Agenda Item # 4

SUB-003017-2024

Software Development Subdivision

SOFTWARE DEVELOPMENT SUBDIVISION

DETAIL SITE PLAN

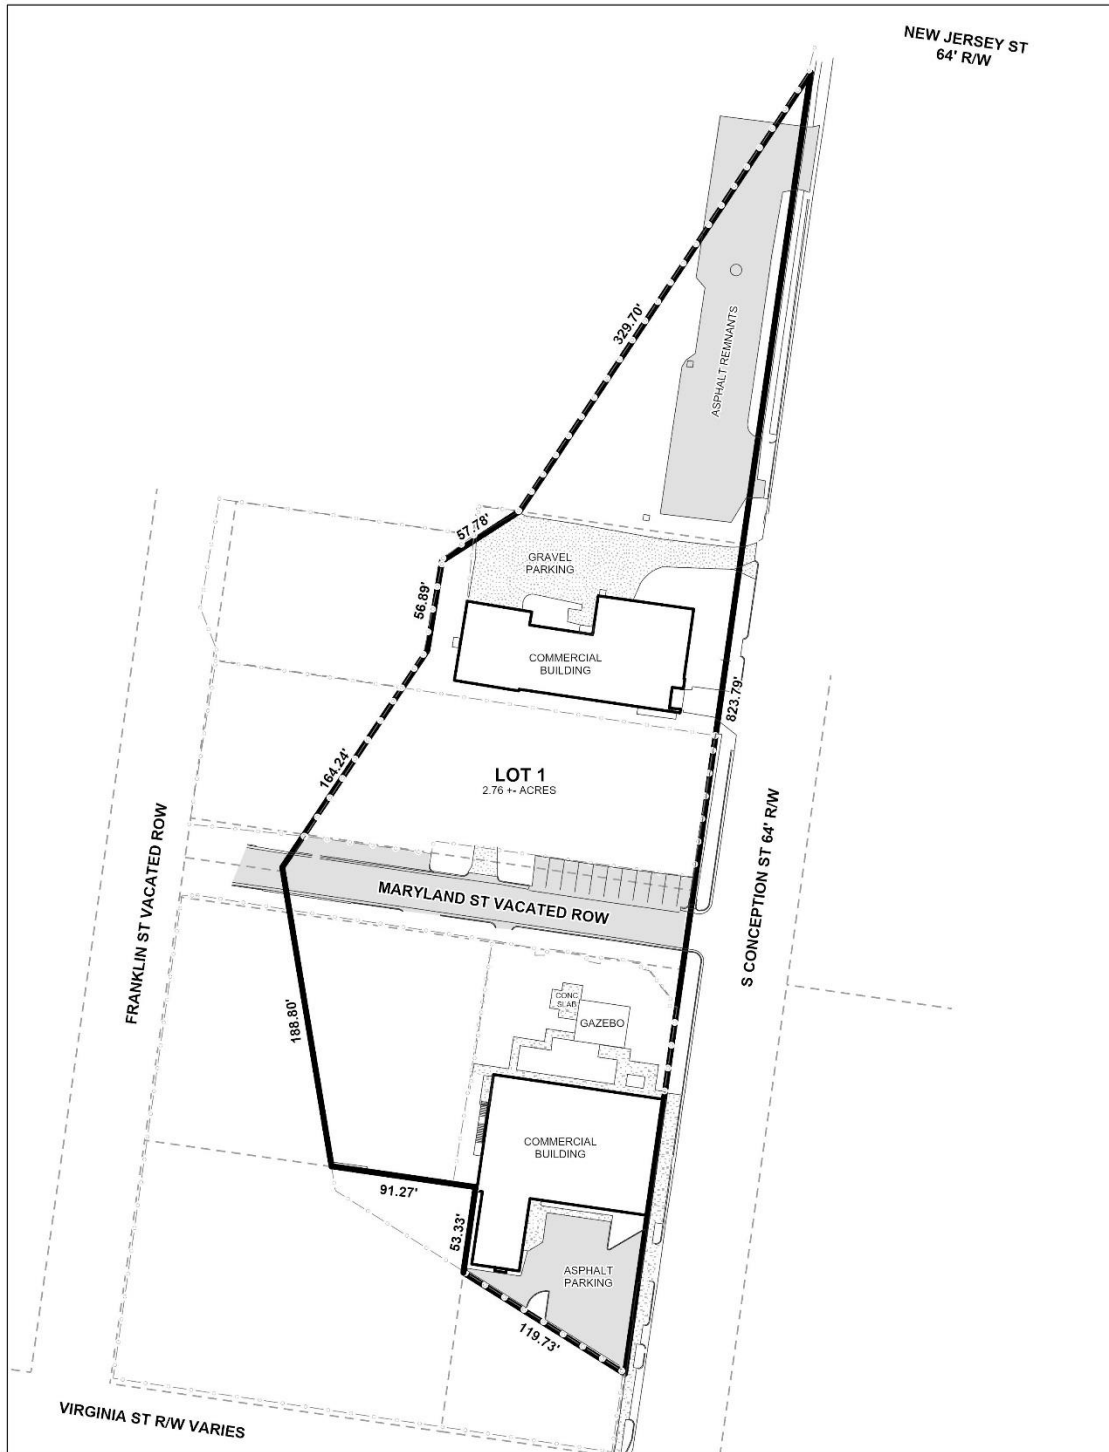
- B. Provide leader arrows to and from the points used on the subdivision east boundary for the two (2) interior dimensions (255.85' and 269.47') – CTF to POB and POB to OTF.

- C. Provide a dimension from the POB to the CRF (R&C#5).
- D. Check and revise either the written legal description or the corner label of the SE corner of LOT 1. Is it a CTF or a Capped Iron Rod (Rebar)?

- E. Show and label all flood zones. New maps went into effect on June 5, 2020.
- F. Show and label the MFFE (Minimum Finished Floor Elevation) on each lot that contains an A, AE, or X (shaded) flood zone designation. BFE = 11.

- G. Provide a signature line for the Surveyor's Certificate.
- H. Add a note to the SUBDIVISION PLAT stating that as shown on the 1984 aerial photo (FLIGHT 30 - #74) LOT 1 will receive historical credit of existing (1984) impervious area towards stormwater detention requirement per Mobile City Code, Chapter 17, Storm Water Management and Flood Control) as follows: LOT 1 – 74,000 sf.

The proposed lot has frontage on South Conception Street, a Major Collector street with an existing 64-foot wide right-of-way. A sufficient right-of-way width is depicted on the preliminary plat making additional dedication unnecessary. This should be retained on the Final Plat, if approved.

The property abuts right-of-way for Interstate 10, which requires a minimum width of 350 feet. It appears that the existing ROW exceeds 500 feet, thus no dedication is required. The site also has frontage on Virginia Street, a Major Collector street requiring a 100-foot right-of-way width. A 150-foot right-of-way width is depicted at this location making additional dedication unnecessary.

The preliminary plat does not illustrate a front yard setback along South Conception Street, Interstate 10, or Virginia Street. Per Section 64-2-21.E of the Unified Development Code (UDC), a 25-foot front yard setback is required for all I-1 zoned properties. As such, if approved, the Final Plat should be revised to illustrate a compliant 25-foot front yard setback along South Conception Street, Interstate 10, and Virginia Street.

The lot size exceeds the minimum area and lot width requirements for properties in an I-1 zoning district, and this information is labeled correctly on the preliminary plat. If approved, the lot size label should be retained in both square feet and acres on the Final Plat; or a table should be furnished on the Final Plat, if approved, providing the same information.

1. Retention of the 64-foot right-of-way width of South Conception Street on the Final Plat;
2. Revision of the Final Plat to illustrate a compliant 25-foot minimum building setback along South Conception Street, Interstate 10, and Virginia Street;
3. Retention of the lot size label in both square feet and acres on the Final Plat, or the furnishing of a table on the providing the same information;
4. Compliance with all Engineering comments noted in this staff report;
5. Placement of a note on the Final Plat stating all Traffic Engineering comments noted in this staff report;
6. Compliance with all Urban Forestry comments noted in this staff report; and,
7. Compliance with all Fire Department comments noted in this staff report.
